Shenzhen SDMC Technology Co.,Ltd.

Class II Permissive Change Letter

FCC ID: 2AW68-NP3081GC

Appearance

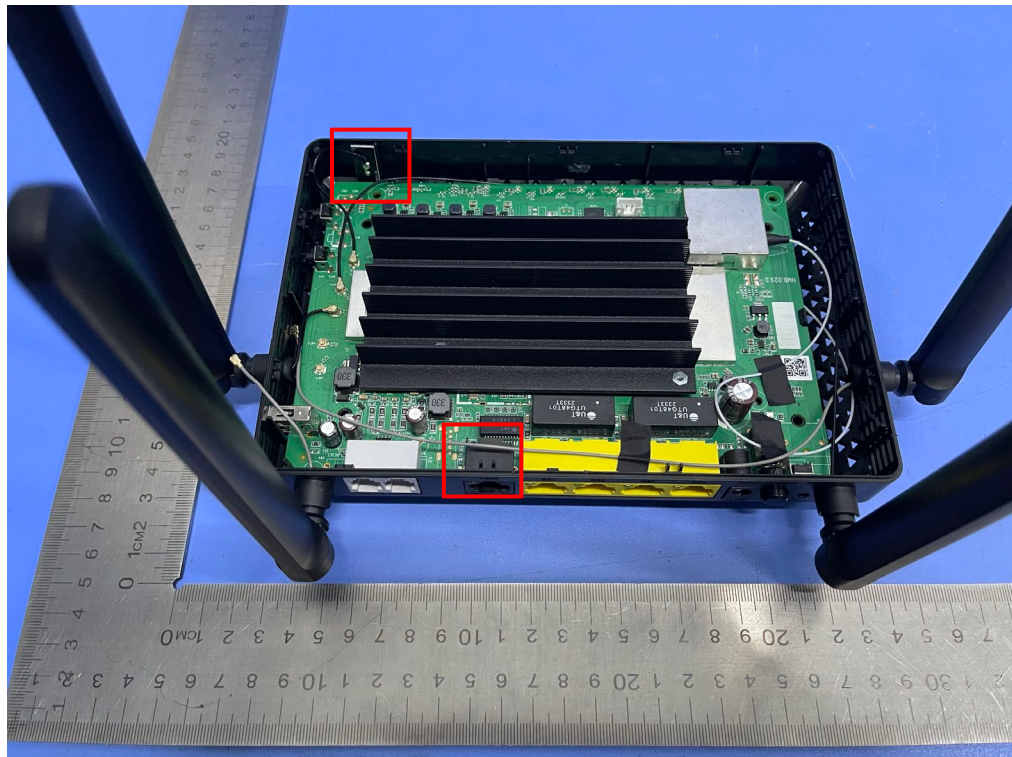
Original

Change to

Change the AC/DC adapter, 5.8G built-in antenna and the 2.5G LAN port is deleted, As there is no change regard RF transmitter portion. The antenna is same type and the Gain reduce from 5.07dBi to 4.66dBi

5.8G built-in Antenna

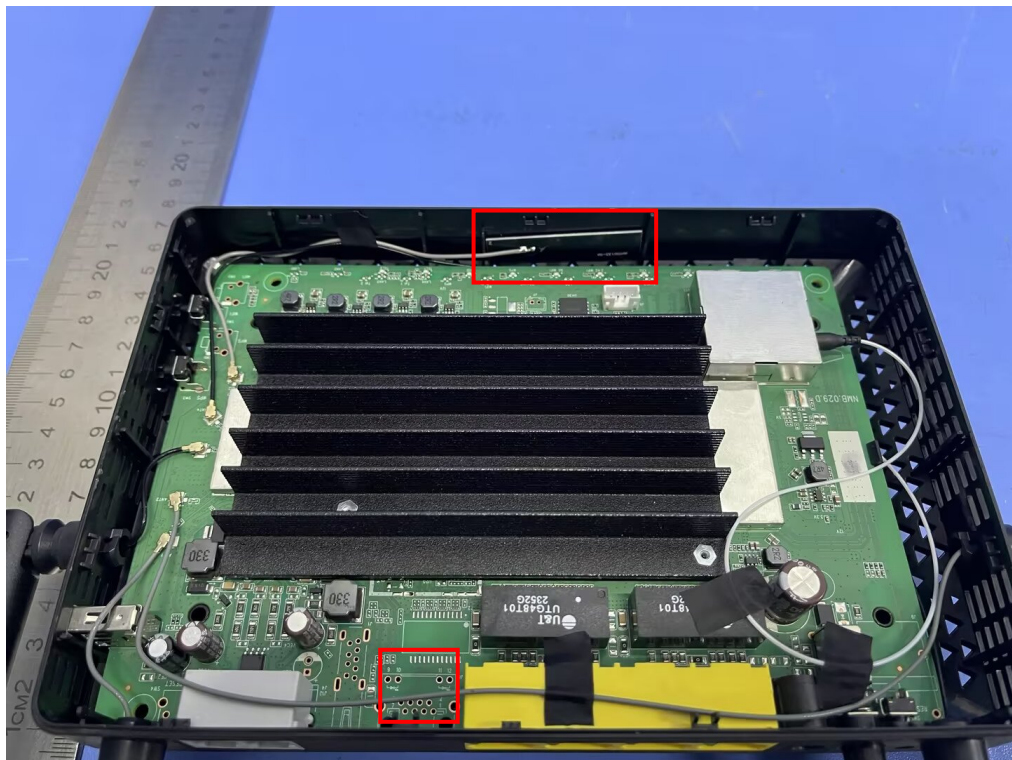
Original

Change to
